1992 Corvette: Recall: Instrument Panel/Left Hand Lower Trim/Brake Pedal Interference

Subject: PRODUCT CAMPAIGN 92C10 - INSTRUMENT PANEL LEFT HAND LOWER TRIM PANEL/BRAKE PEDAL INTERFERENCE

Model and Year: 1992 CHEVROLET CORVETTE

Bulletin Number: 92C10 - (04/23/1992)

Figure 1

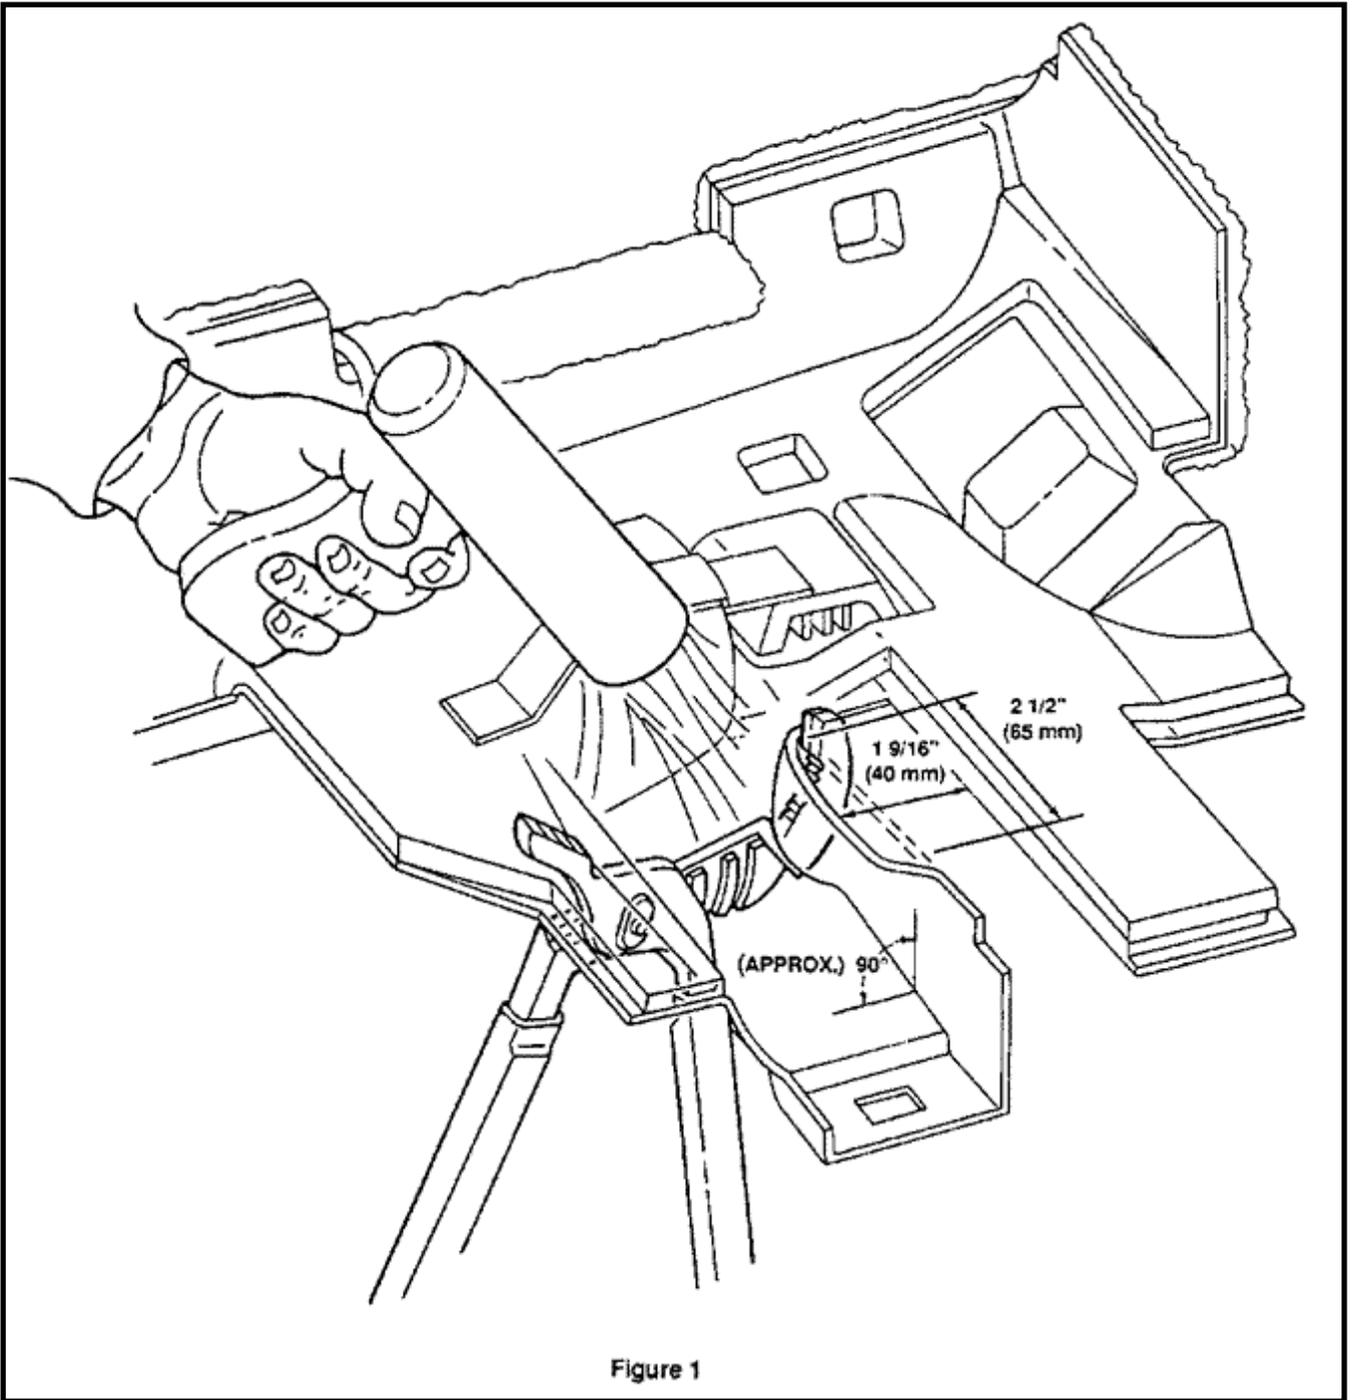
General Motors has determined that certain 1992 Chevrolet Corvette model vehicles may experience their brake lights staying on and/or a lack of pedal return, which may cause light brake drag. Brake drag may, in turn, cause roughness, vibration, noise, a noticeable slowing of the vehicle and/or automatic transmission downshift when attempting to maintain a constant speed. Also, the cruise control may not set or the ASR (Anti-Slip Regulation - "Traction Control") may not function.

To prevent this condition from occurring, dealers are to inspect for proper clearance between the brake pedal arm and the instrument panel (I/P) left-hand lower trim panel. If clearance is not sufficient, the trim panel will be modified with a heat gun.

1. Remove I/P left-hand lower trim panel (per Preliminary Service Manual, Section 8C-33).
2. Lift away foam sound deadener from area shown in Figure 1 and tape out of way.
3. Using a heat gun, warm trim panel area shown in Figure 1. **USE CARE TO WARM COMPLETE AREA EVENLY.**
4. Using Channel Locks size 16 or larger, place near upper left-hand corner of I/P left-hand lower trim panel as shown in Figure 1. Quickly reform brake pedal opening to configuration and dimensions indicated in Figure 1. If necessary, Channel Locks may be moved downward during initial reforming and/or steps 3 and 4 may be repeated to obtain minimum clearance of 2mm between brake service pedal arm and I/P left- hand lower trim panel.

Notice: To lessen Channel Lock imprint, place smooth shim stock or aluminum face cover between Channel Lock face and warmed surface of I/P left-hand lower trim panel.

5. Reinstall I/P left-hand lower trim panel. Remeasure clearance between trim panel and brake pedal arm along entire length of pedal travel, using "INSPECTION" procedure on page 2.
6. Install Campaign Identification Label.
